Indian Point Nuclear Generating Unit No. 3

Stretch Power Uprate License Amendment Request Package

Proposed Changes to Technical Specifications:

Stretch Power Uprate (4.85%) and Adoption of TSTF-339

Figure 2.1-1
Rated Power (Percent of 3067.4 MWt)

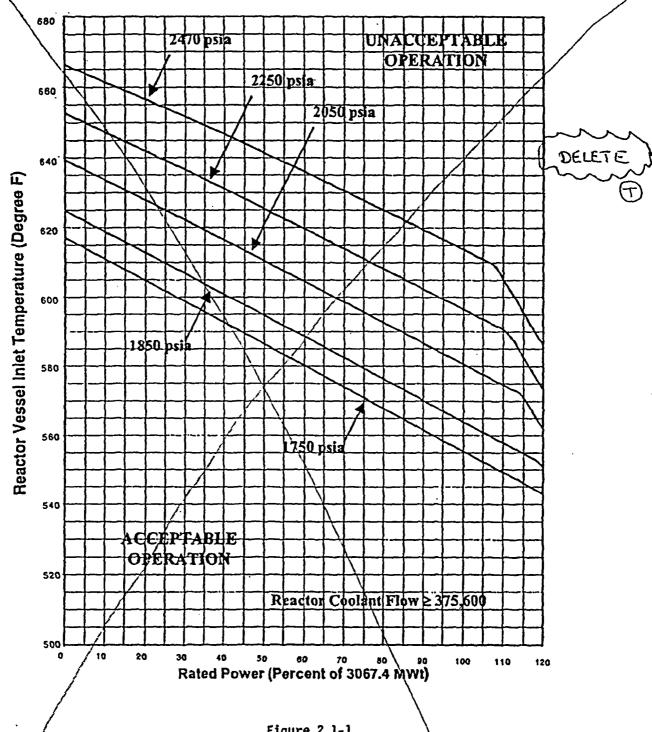
- Relocating updated Figure 2.1-1 (Reactor Core Safety Limits) to the COLR,
- Adding new requirements 2.1.1.1 and 2.1.1.2 for DNB and peak fuel centerline temperature limits, respectively; and
- Related Bases changes as specified in TSTF-339.

The Reactor Core Safety Limits curve has been updated to reflect the proposed stretch uprate conditions. This new curve, being relocated to the COLR, is shown in Figure 6.3-1, Section 6.3 of WCAP-16212-P, provided in Attachment III.
